ADDENDUM

PROJECT: Forestside Estates
Attmar & Palleschi Drive
Brampton, Ontario

PROJECT NO.: 18-017

ADDENDUM NO. E-4

TITLE
**3RD FLOOR PLAN
ELECTRICAL**

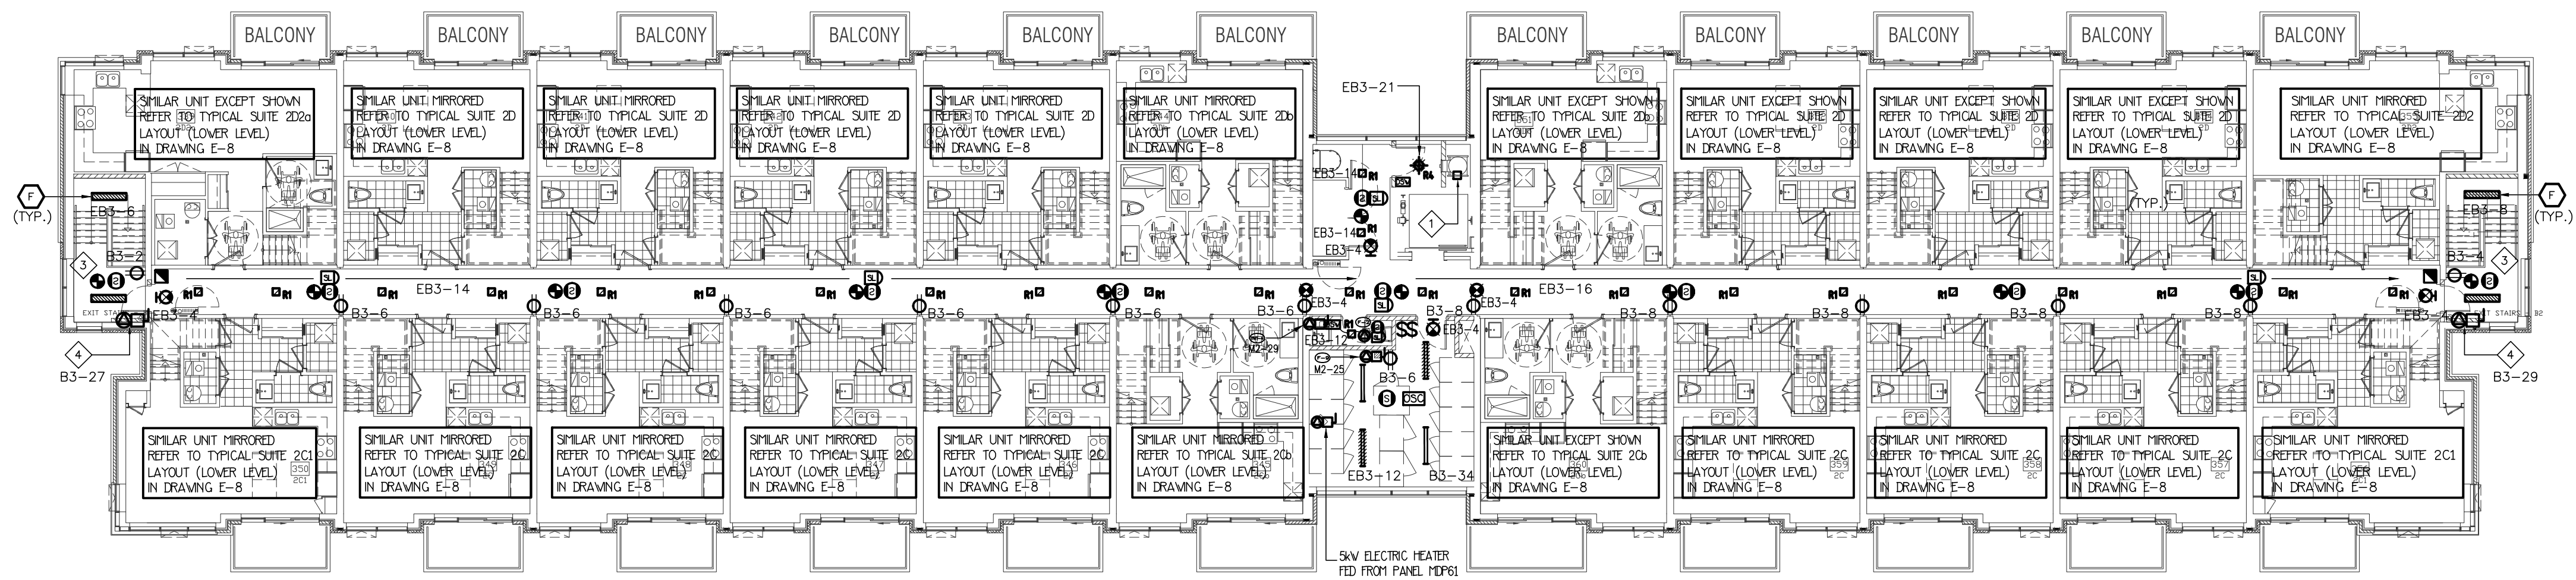
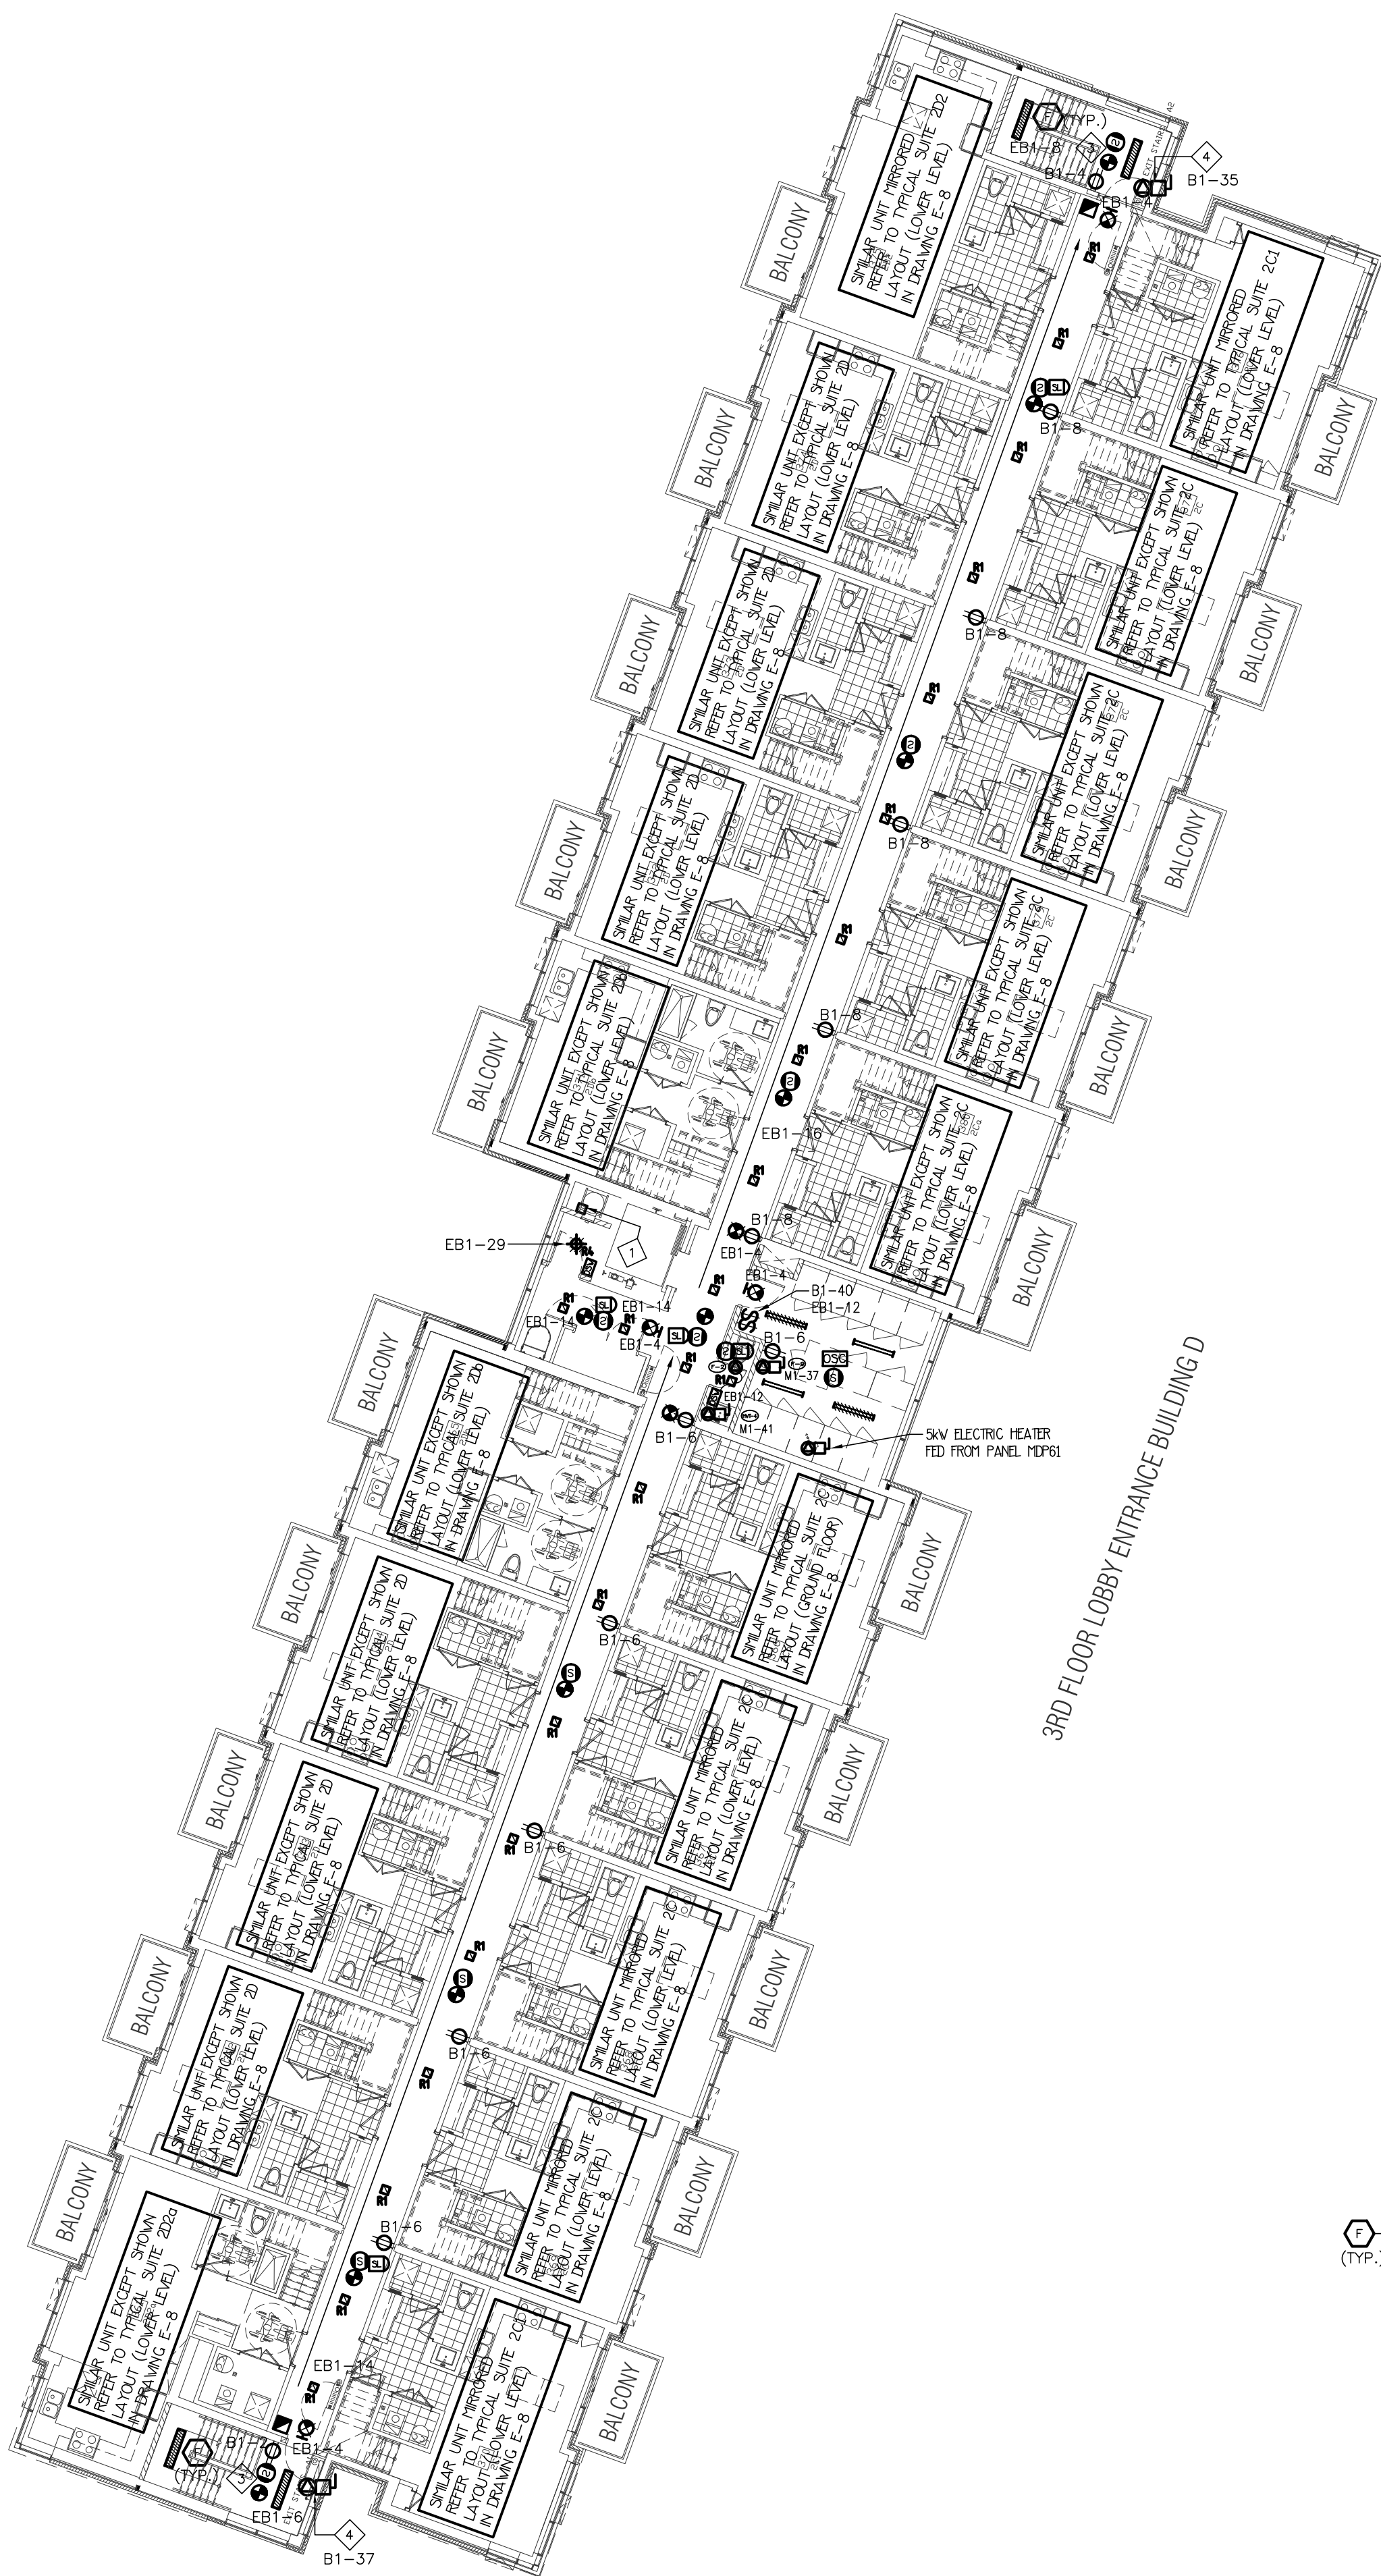
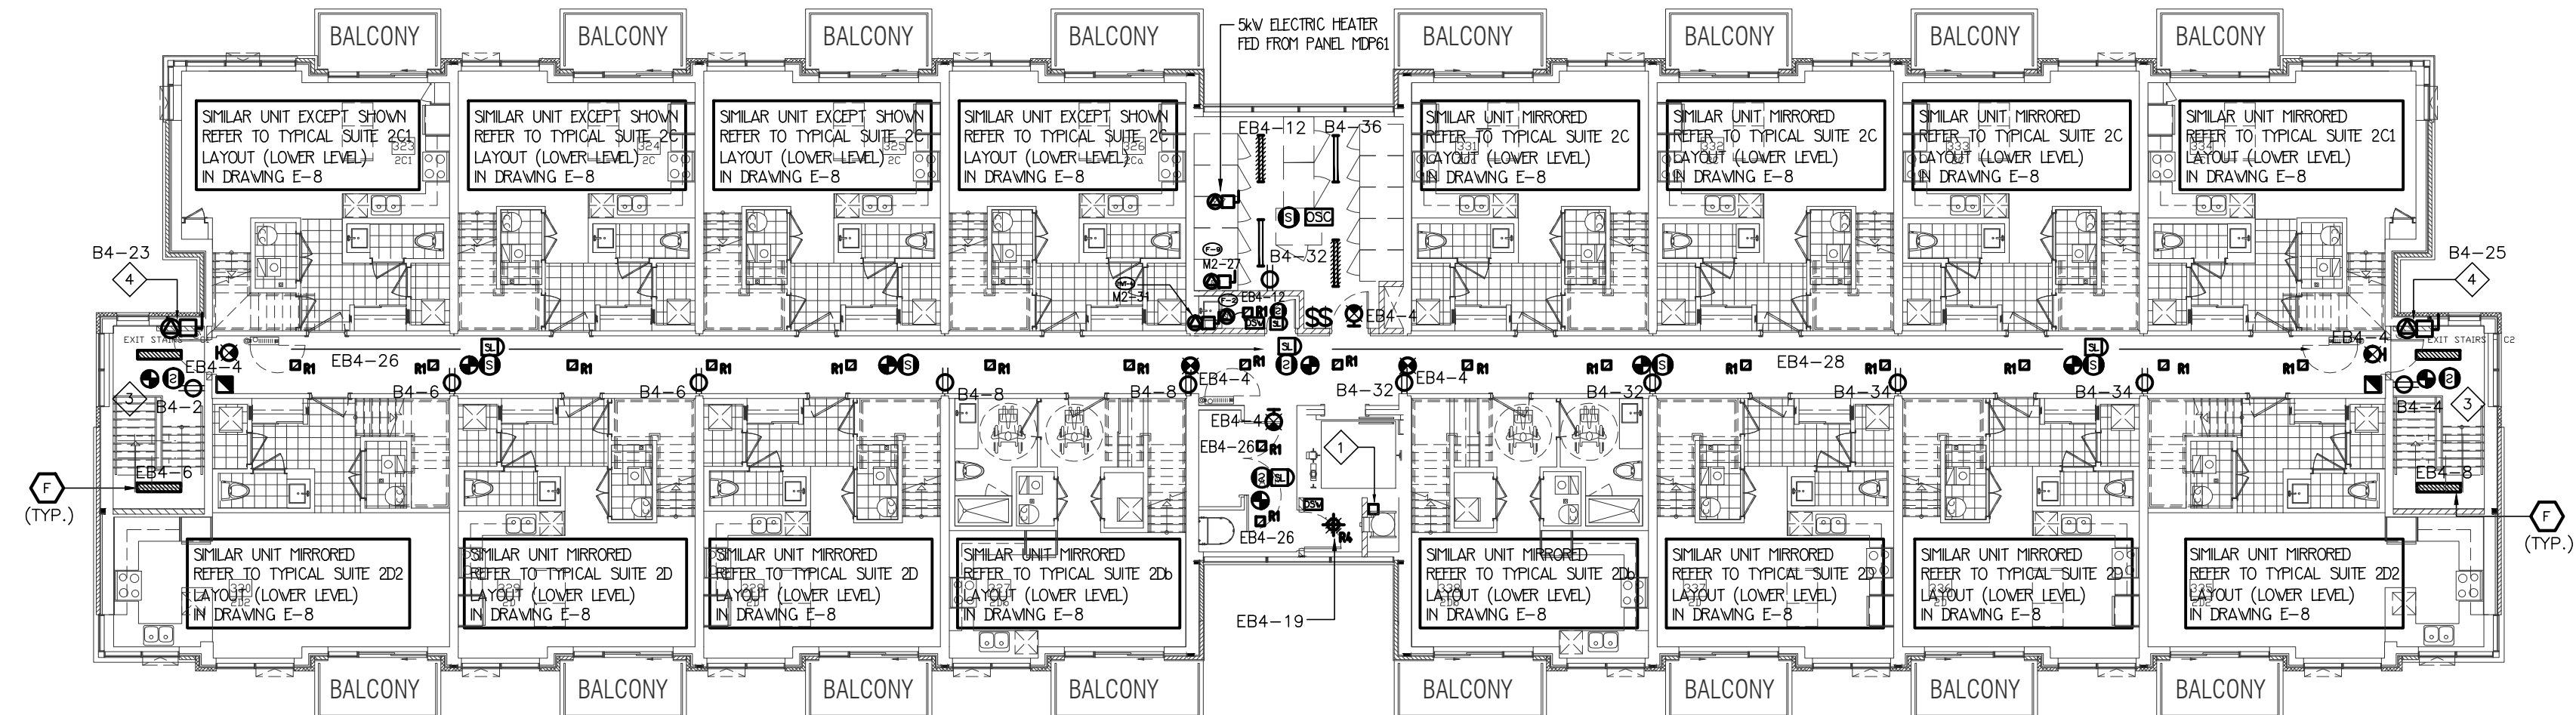
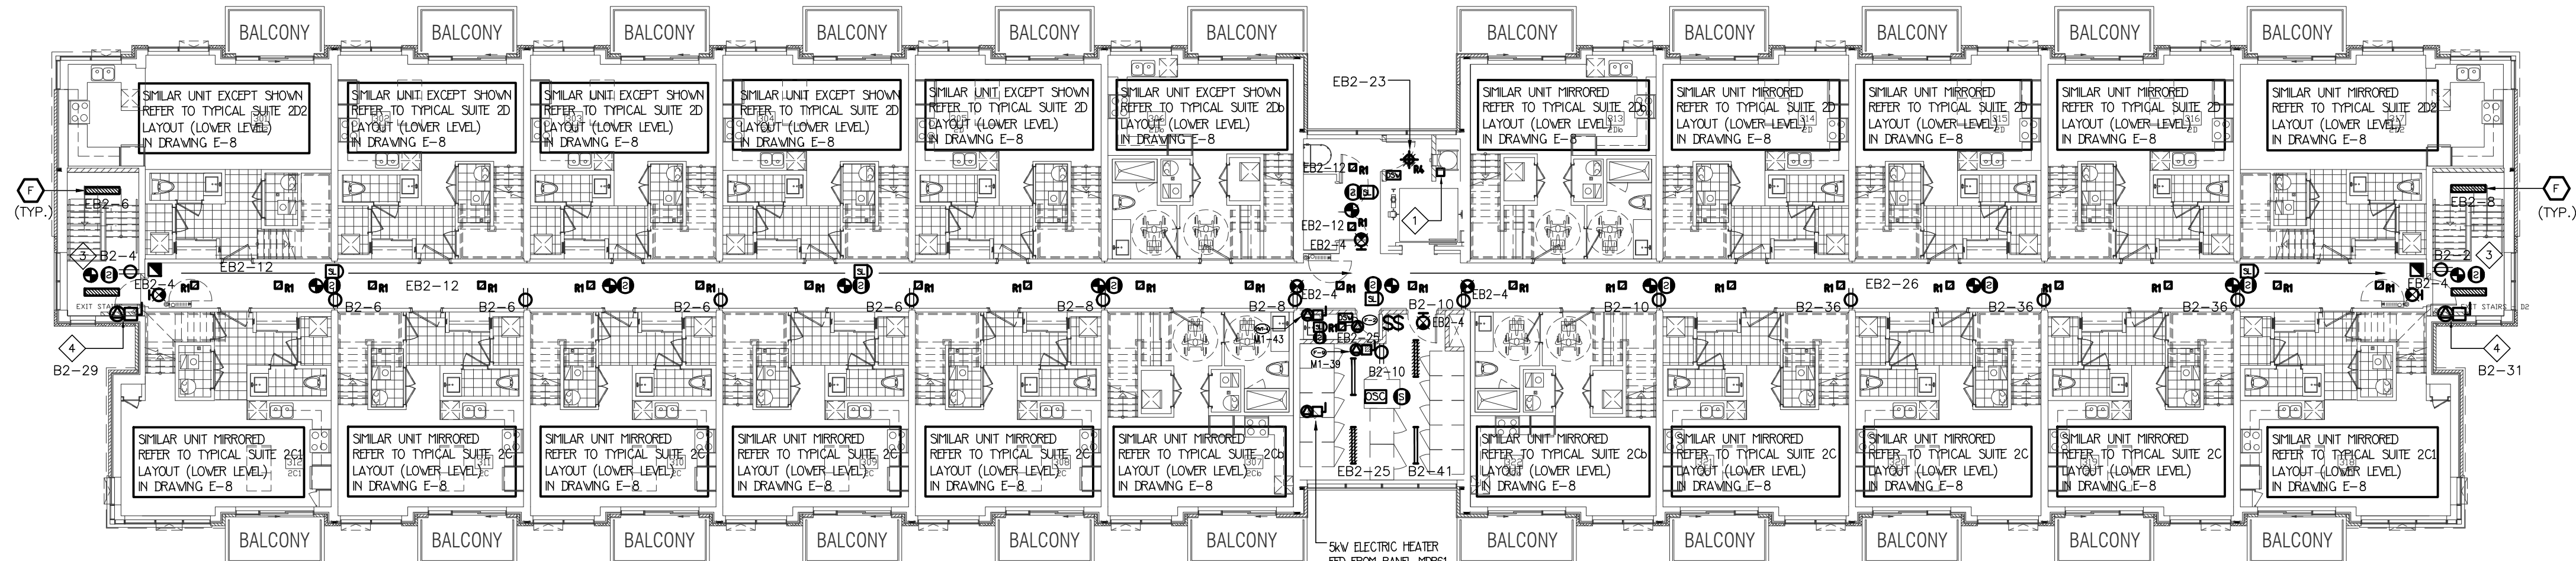
3.1 Revise: Floor plan background suit latest arch drawings as shown.

3.2 Delete: Split system blower & coil 'E-5' & condenser units 'E-6' for lobby area.
